Your Ref: SSD-75493483

SD-75493483 – Environmental Impact Statement – Forest Lodge Integrated Seniors Living

Figure 2: Above e00000xcerpts from the Seniors Housing Design Guide showing main entrances linked with porte-cochere and ambulance access.

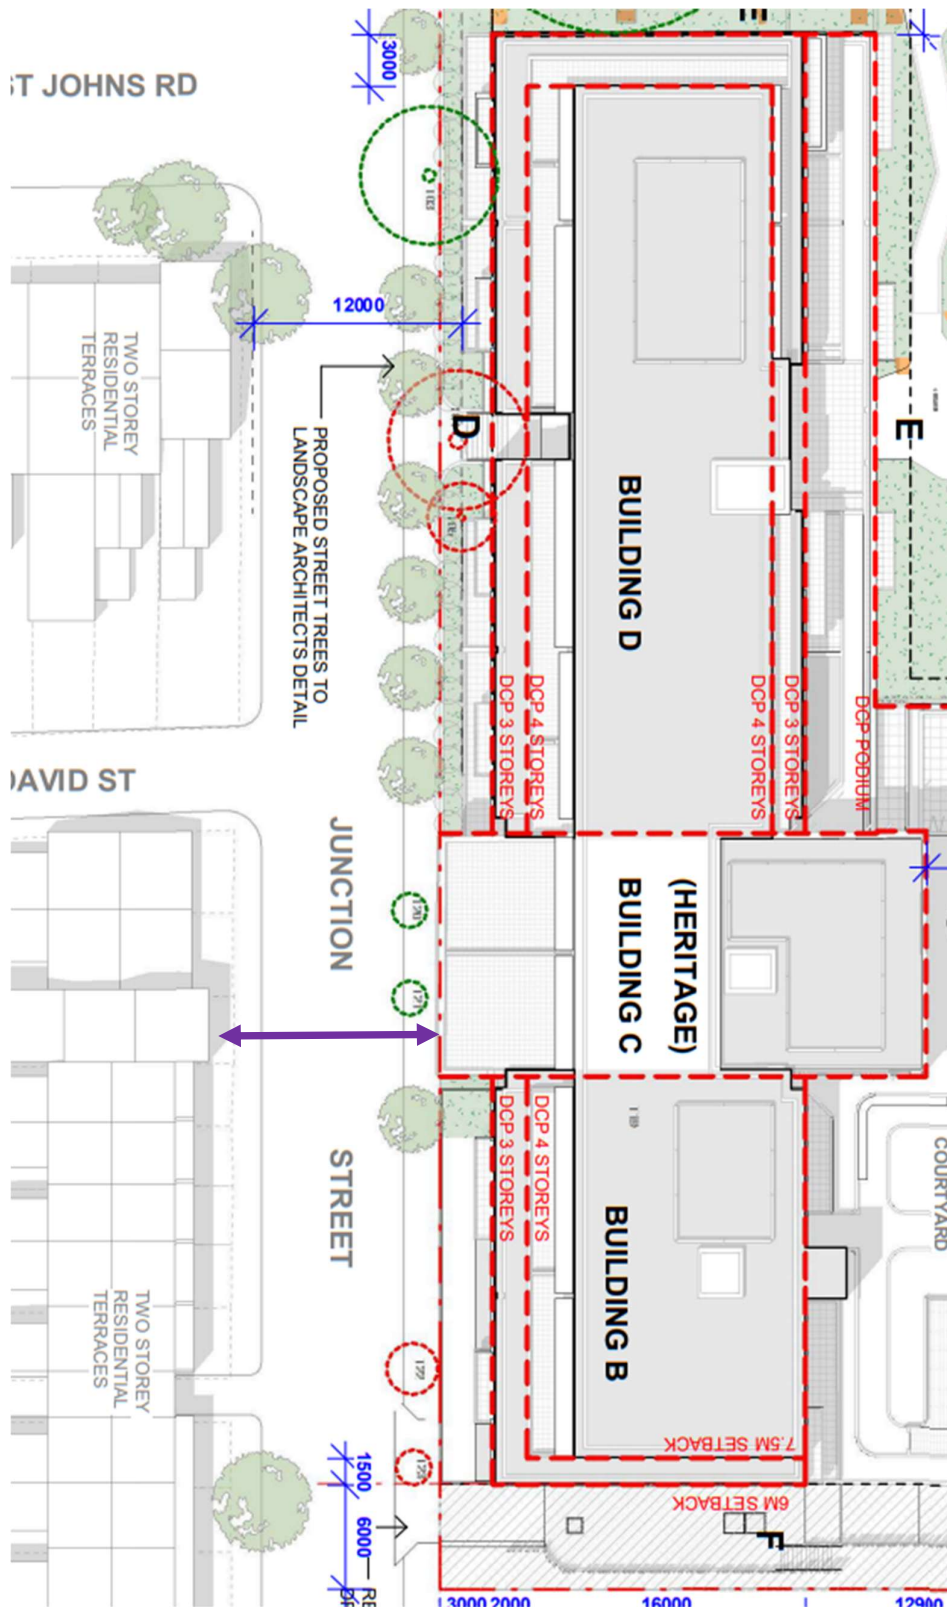
Normally, the main entrance is sited well within the seniors housing development behind a porte-cochere (see Figure 2). This is both for the convenience of residents and to minimise the impact on the visual and acoustic privacy of adjacent neighbours. For example, at the applicant’s Rosebery Seniors Living Development (SSD-49320959) the main entrance is approximately nine metres from the street boundary (see Figure 5). At a comparable seniors housing development in Cremorne⁷ the main entrance is approximately 15 metres from the street boundary. Neighbours living opposite these developments also have a further privacy buffer of the width of the street and footpaths.

This impact is intensified by the decision to have—contrary to the guidance provided in the Seniors Housing Design Guide—the main entrance separated from the porte-cochere. Most of the pedestrian traffic, supermarket and other deliveries are likely to utilise the main entrance where the concierge is located, and the main entrance can be accessed by residents, families and visitors 24 hours per day, 7 days per week.⁹ There is also likely to be increased vehicle noise from vehicles parking and unloading while making deliveries.

Figure 4: Photo taken from approximately 5 metres inside our living area – the location of the main entrance—which overlooks our ground floor living, dining and kitchen areas—is outlined in yellow. When the curtain is up you can clearly see at least 3 metres inside the Heritage Building

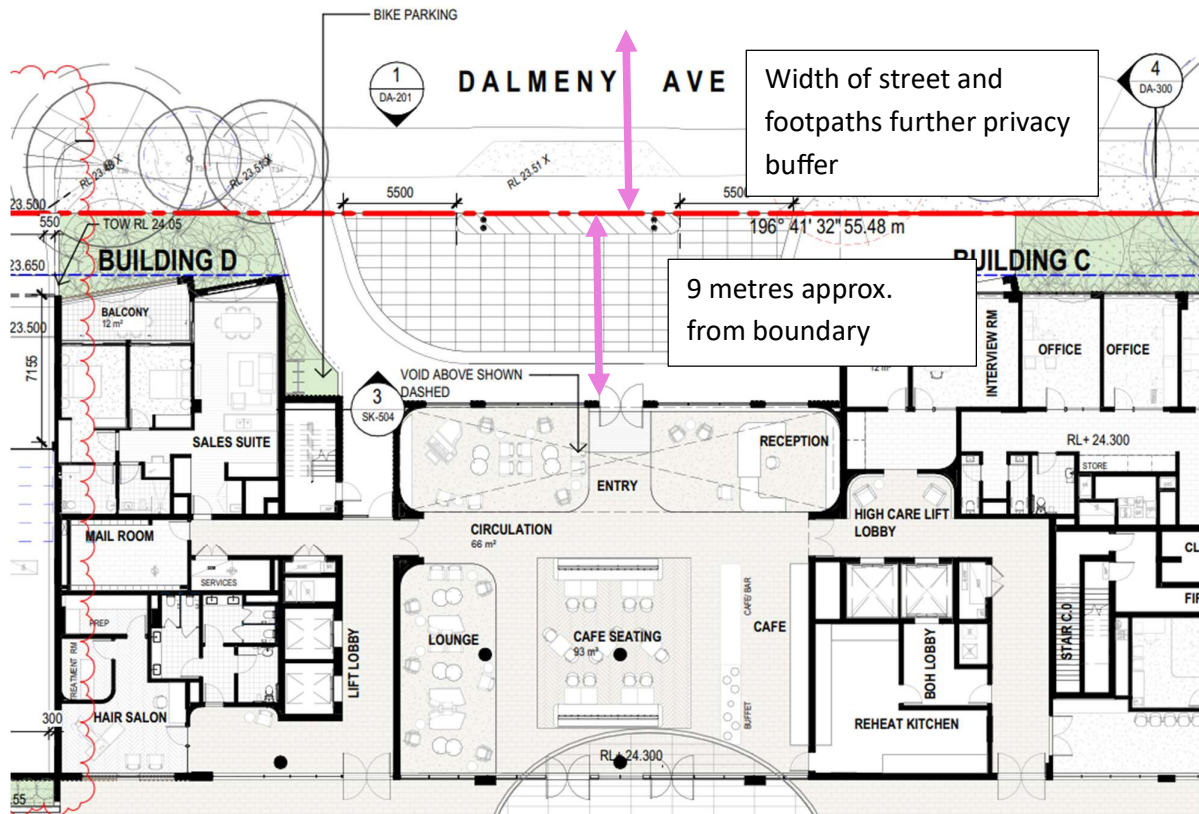
The applicant has located the main entrance to the proposed development in the Heritage Building—the only building built to the boundary (see Figure 1). The entrance is the point on the front wall of the Heritage Building where people will enter and exit the complex.

development will overlook our ground floor living, dining and kitchen areas (see Figures 3 and 4).⁸ The noise of pedestrian traffic to the main entrance of the building will also impact unreasonably on our acoustic privacy.

Figure 7: Excerpt from Landscape Master Plan showing virtual no greening on Junction Street from the Heritage Building to Kimber Lane – area outlined in red.

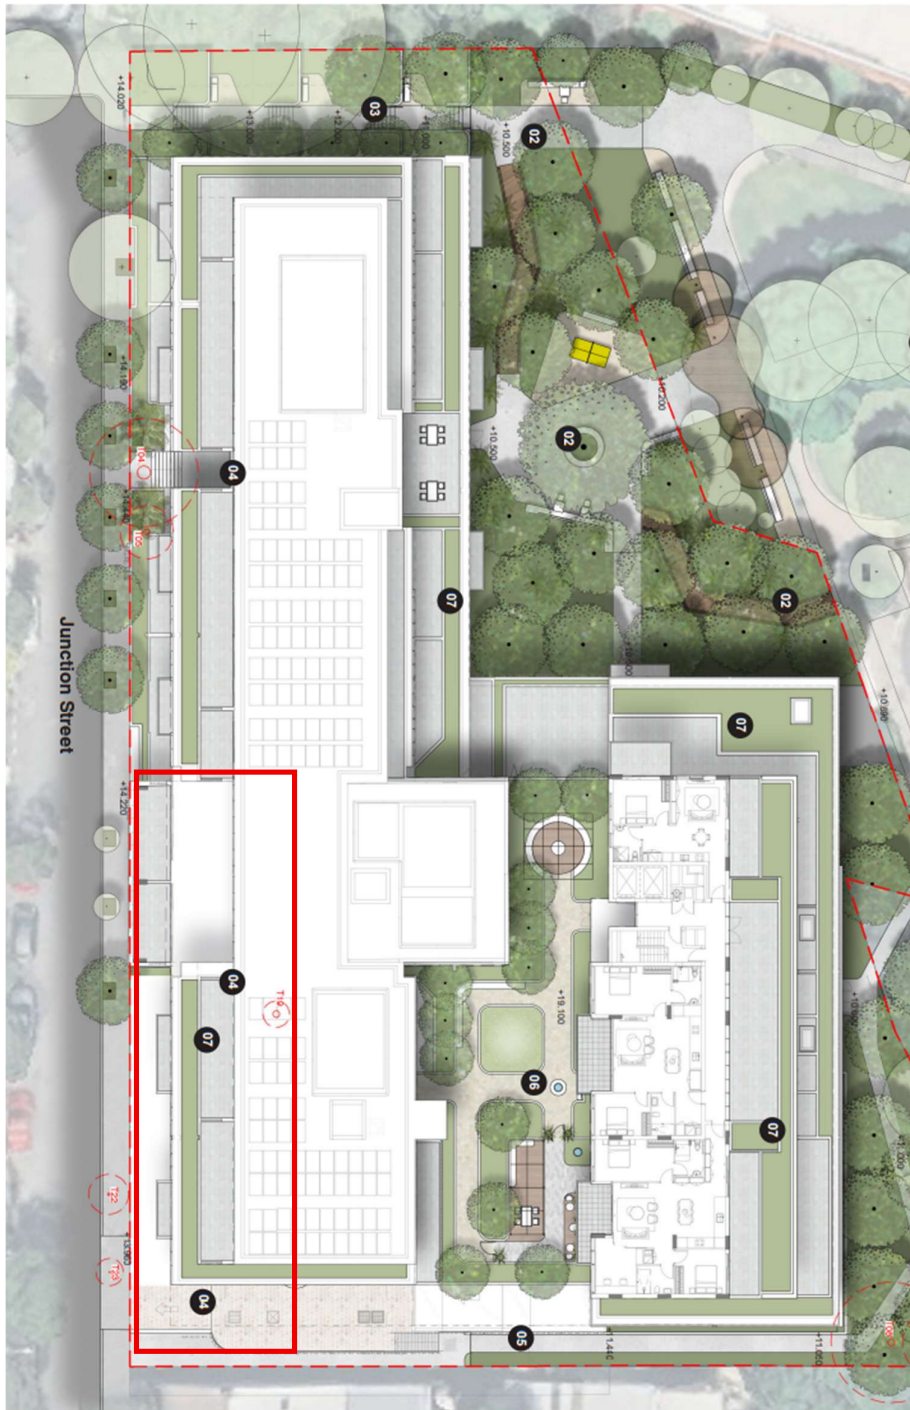
We welcome that the proposed development is providing trees and landscaping, but object to the fact that the greening is overwhelmingly to be located on the Larkin Street side of the development, with very little at all on the western side of Junction Street between the Heritage Building and Kimber Lane (see Figure 7).

In accordance with principle 3(e) of the Housing SEPP we ask for increased canopy cover between the Heritage Building and Kimber Lane on the western side of Junction Street to minimise the adverse climate and environmental impacts of the proposed development on the residents of Junction Street.

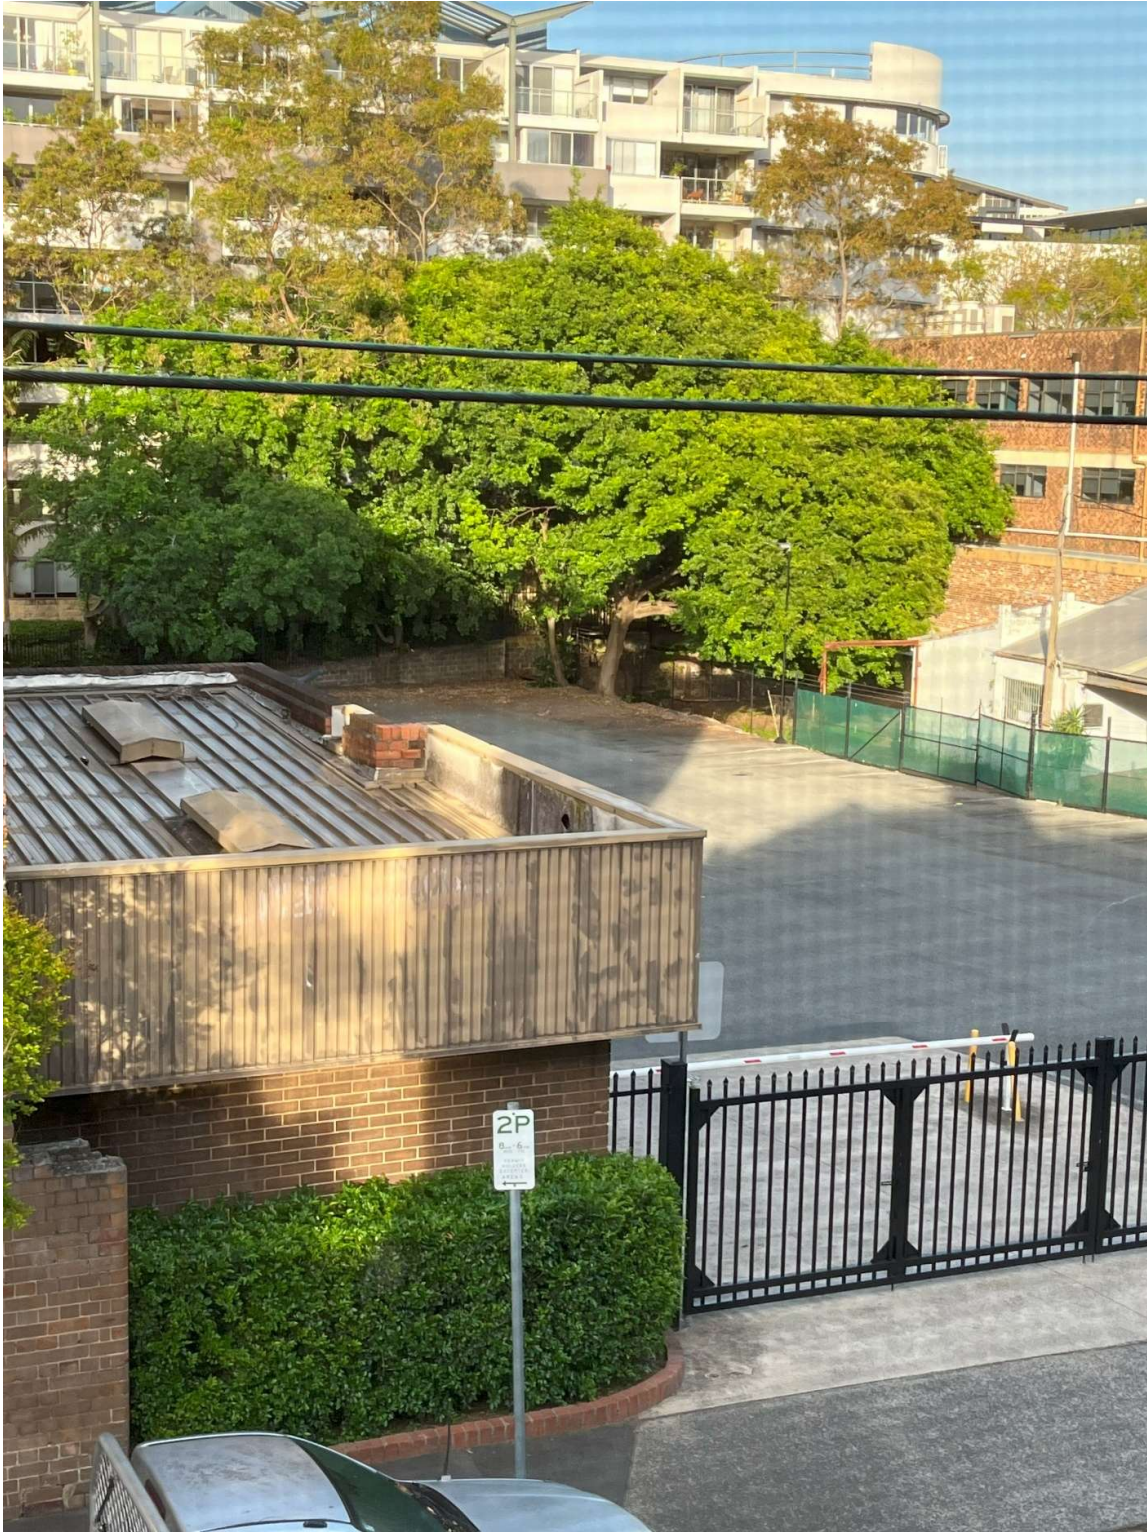
Our views of the large trees at the rear of the street will also be blocked by the bulk of the proposed development further reducing our amenity (see Figure 8).

Figure 15: Anglicare St John's Village has the kind of wide, level footpaths on either side of the road that you would expect outside a seniors housing development.

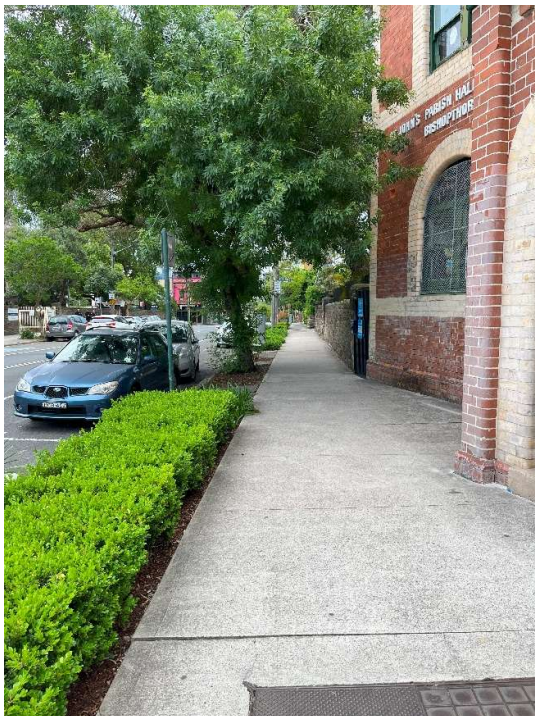
For the kind of footpaths that you would expect to see around a state significant seniors housing development, please refer to Figure 15.
